RE: CONCORD AVENUE – WATER MAIN, STREET & SIDEWALK
RECONSTRUCTION – FILE NO. 5150

ADDENDUM NO. 1

**Concord Avenue
Addendum #1
February 9, 2010**

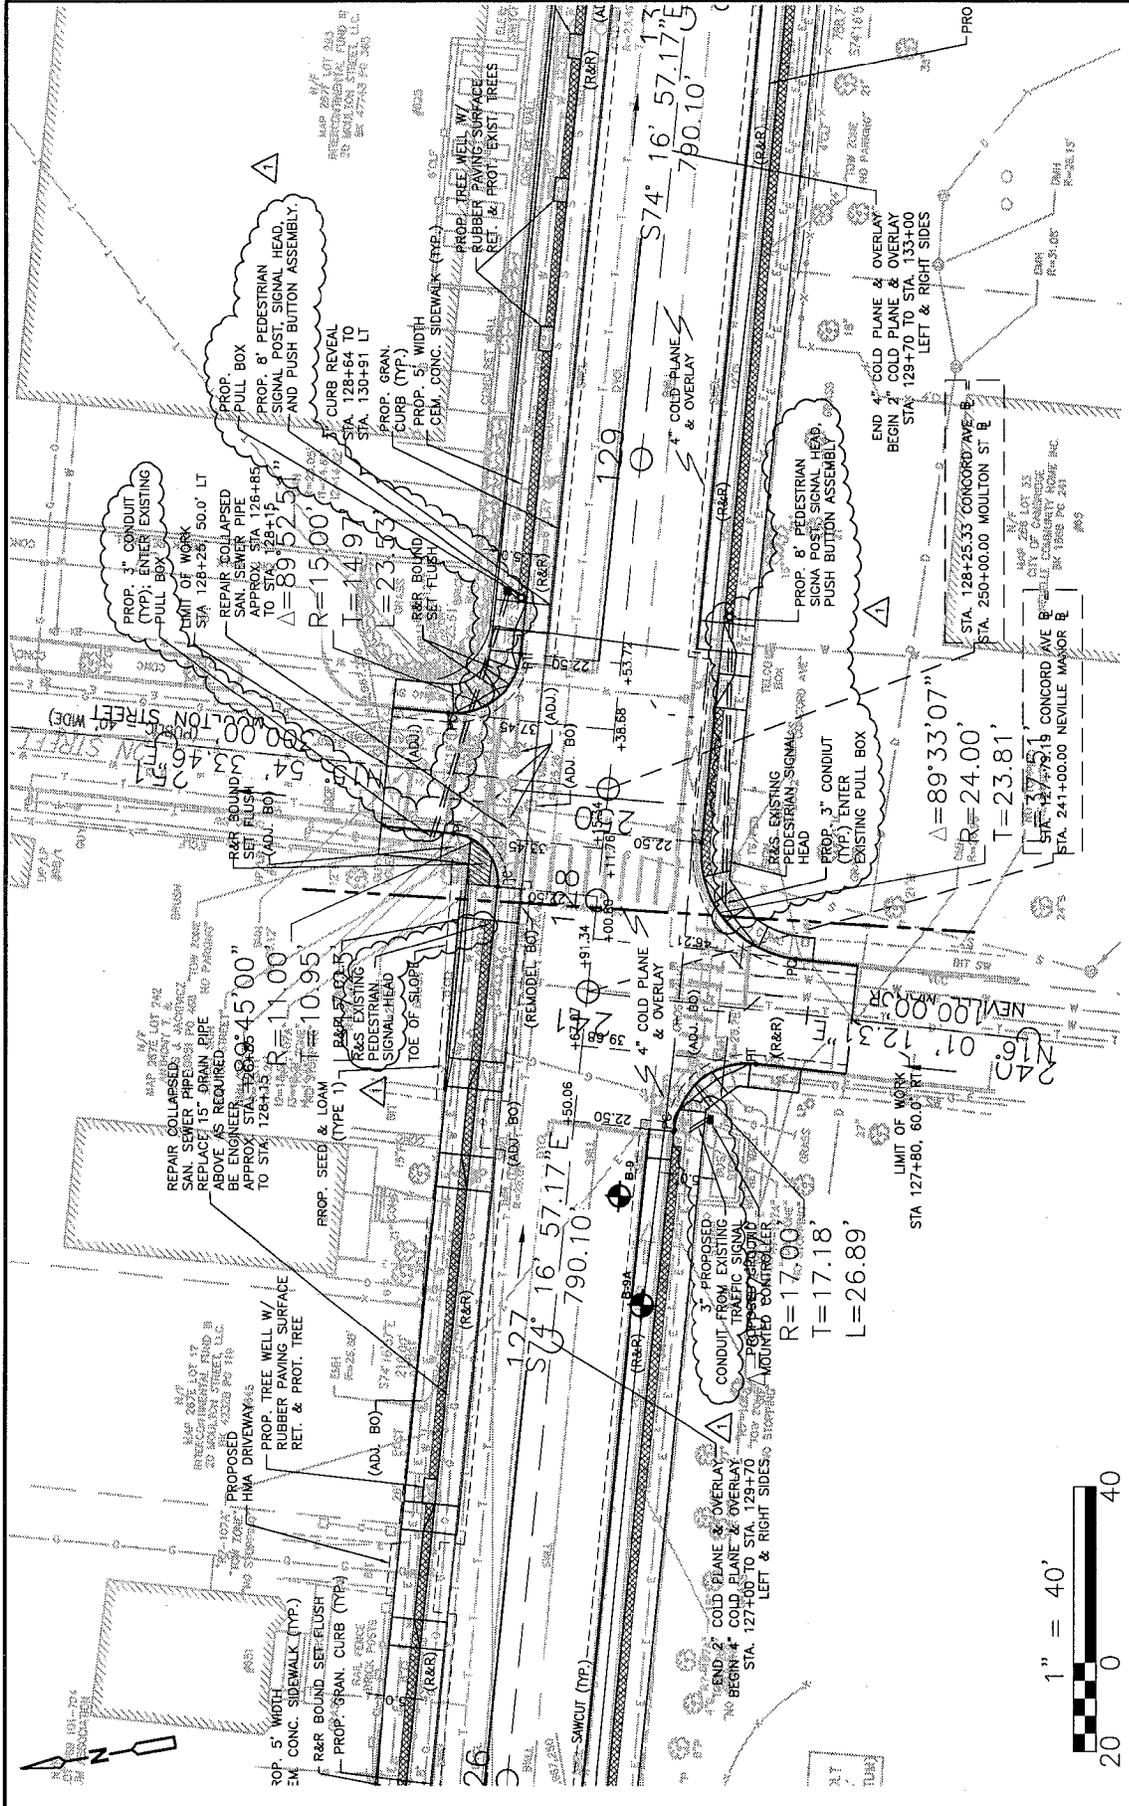
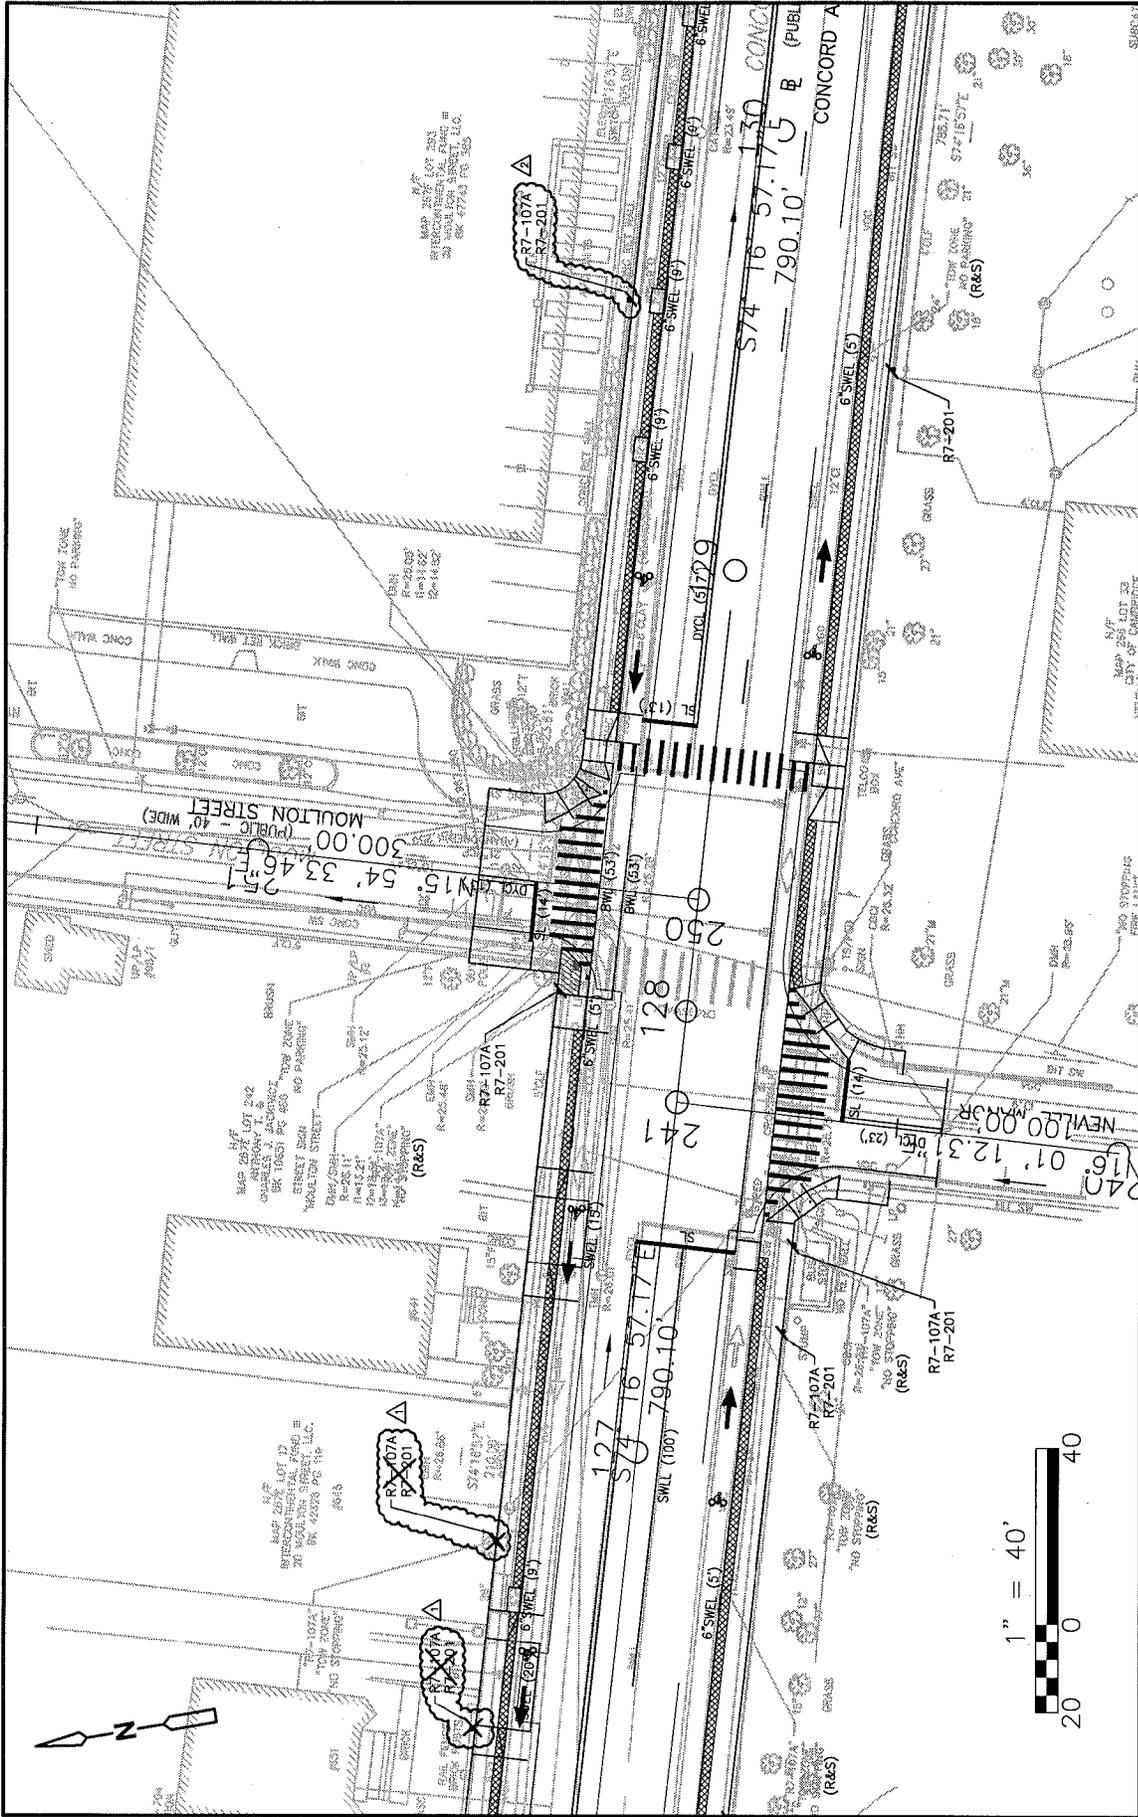
9. Revise signal work at Moulton Street to accommodate new crosswalk location and relocate westbound bus stop

- a. See Sketches SK-9 and SK-10
- b. Add items 811.22, 811.31, 812.32 to bid form
- c. Add Specifications for ITEM 811.22, 811.31 and 812.32 (See attached)

NUMBER	DESCRIPTION
Δ	ADDED NOTES & CONDUIT, MOVED PEDESTRIAN FLASHER

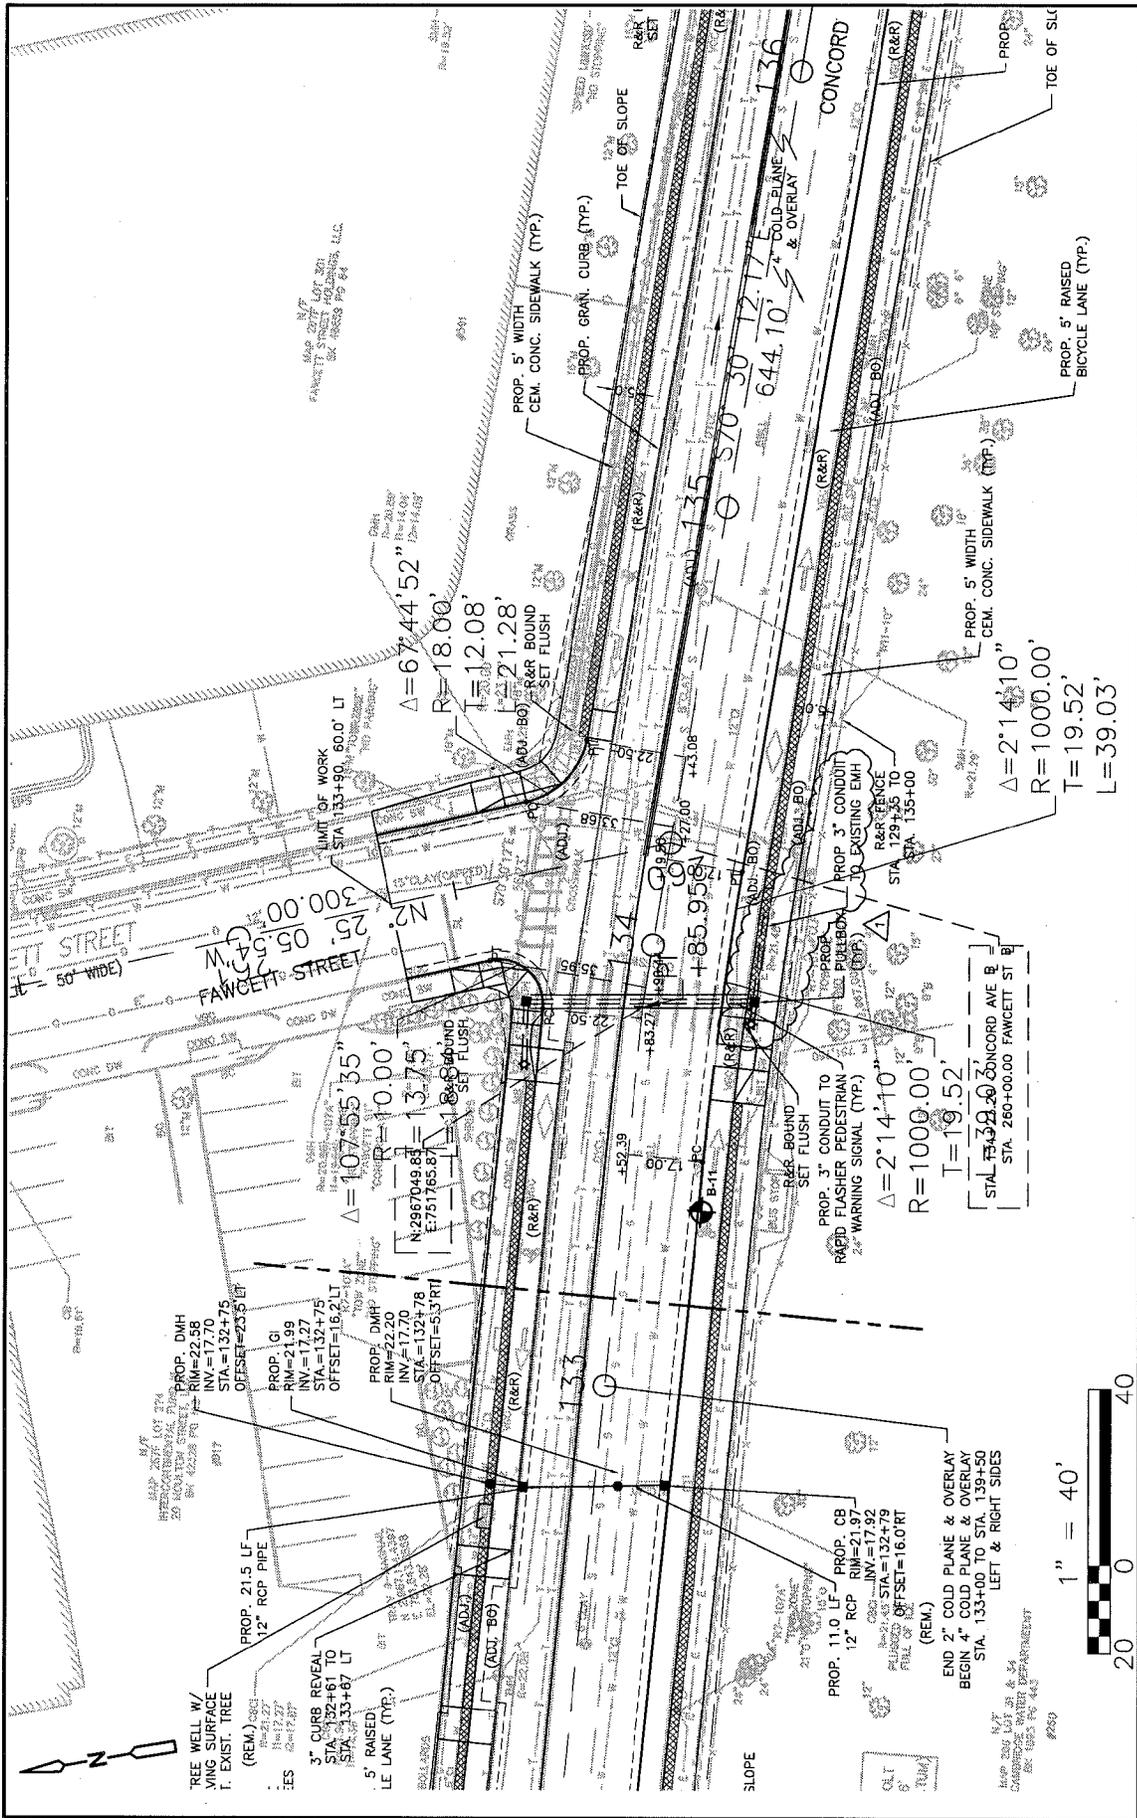
10. Revised conduit detail for pedestrian flasher at Fawcett Street – Sketch SK-11

FAWCETT STREET AND
CONCORD AVENUE

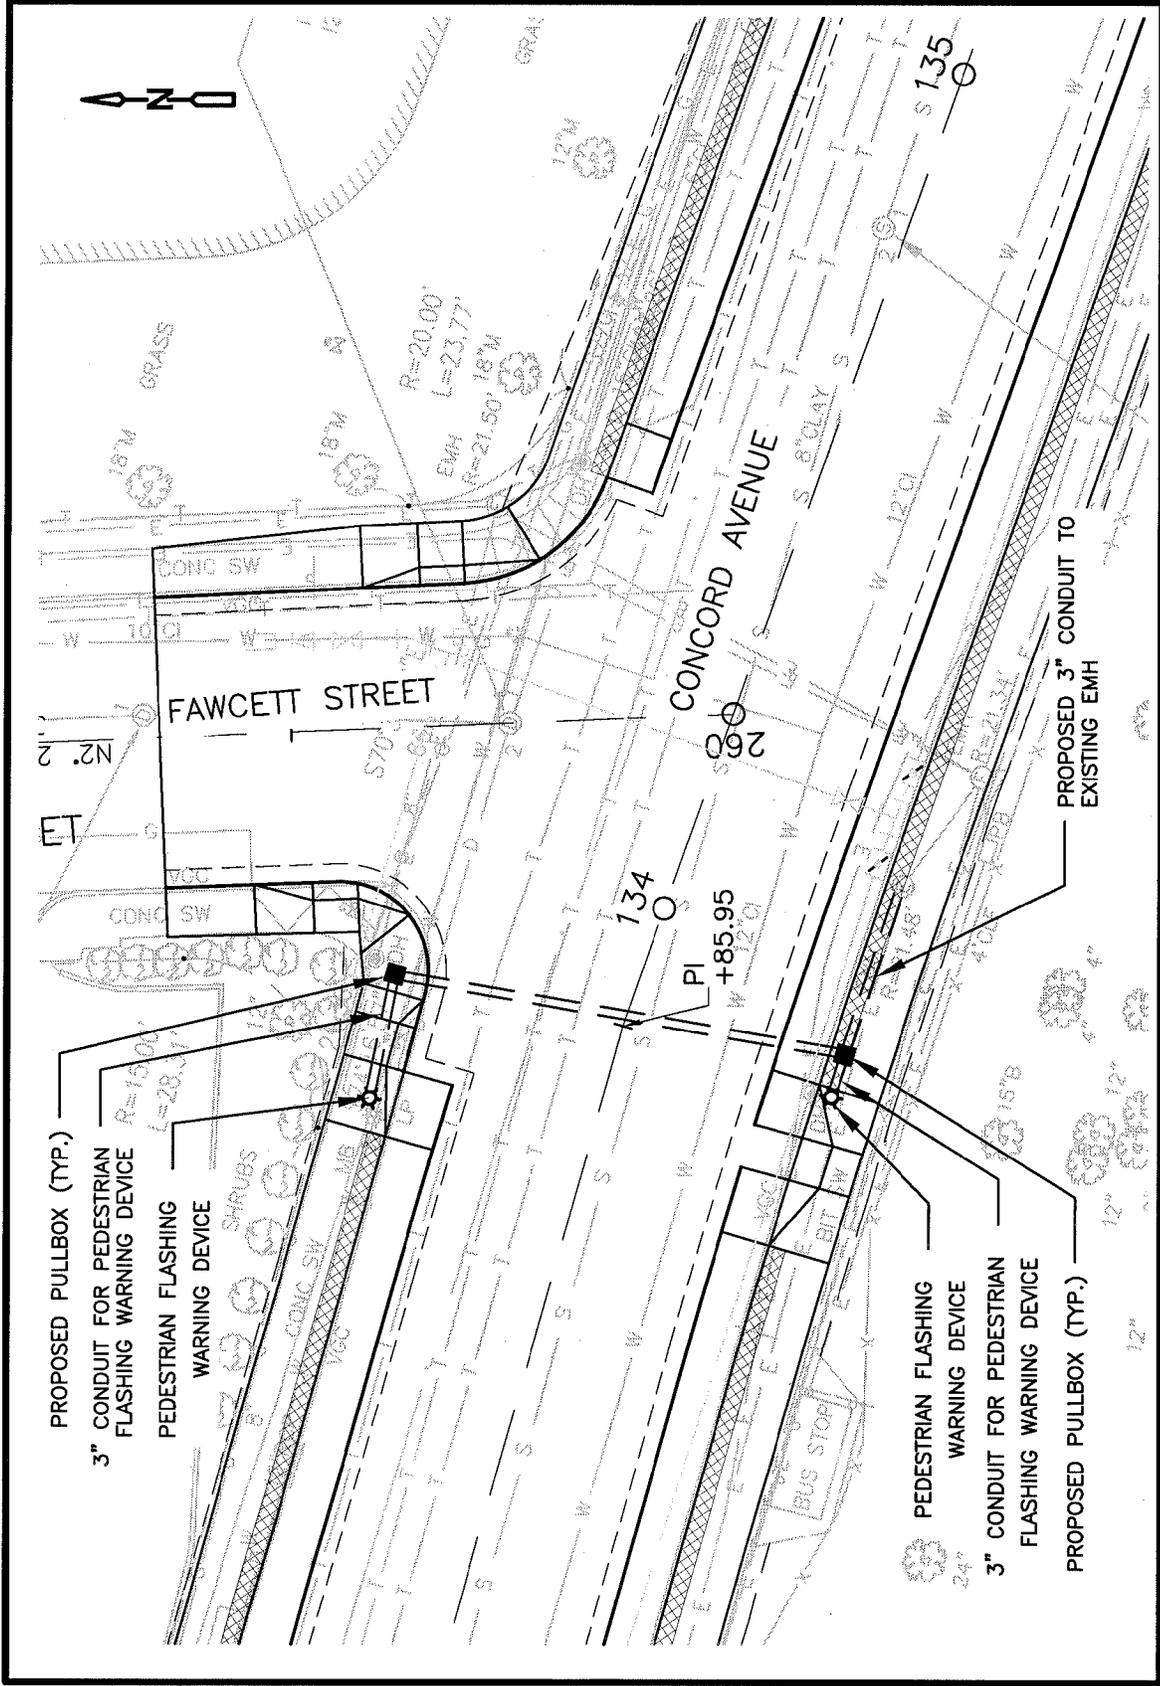
19. Sketches submitted to NStar showing proposed conduit locations, subject to NStar approval. See sketches
 - a. Fawcett Street and Concord Avenue
 - b. Neville Manor and Concord Avenue
 - c. Smith Place and concord Avenue

PETITION PLAN

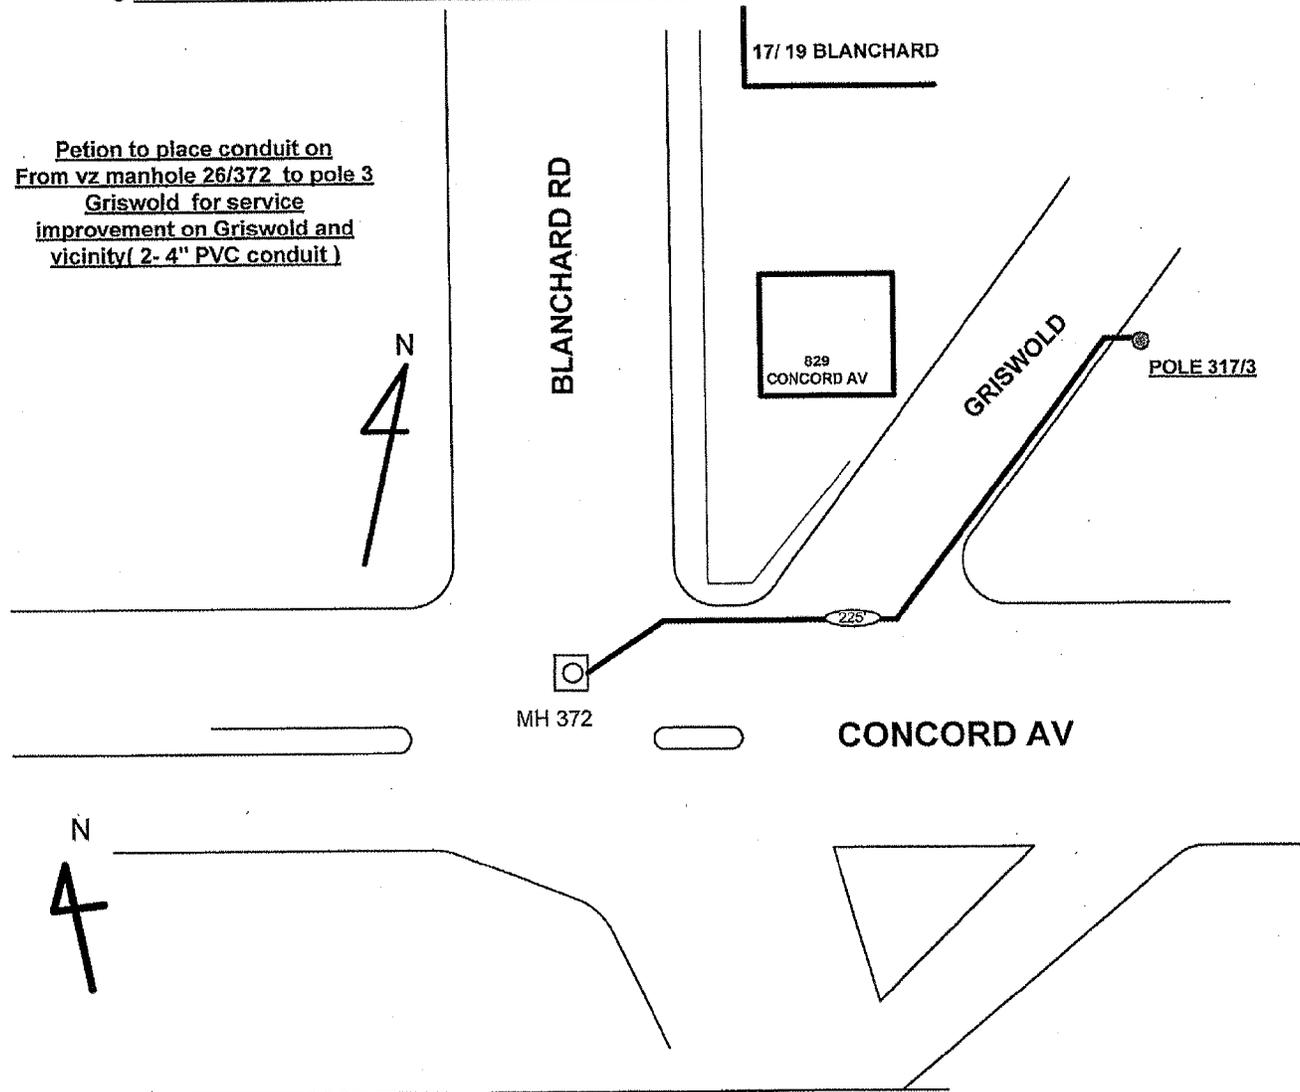
21. Sketches of proposed work received from Verizon, subject to approval by the Pole and Conduit Commission (see attached)
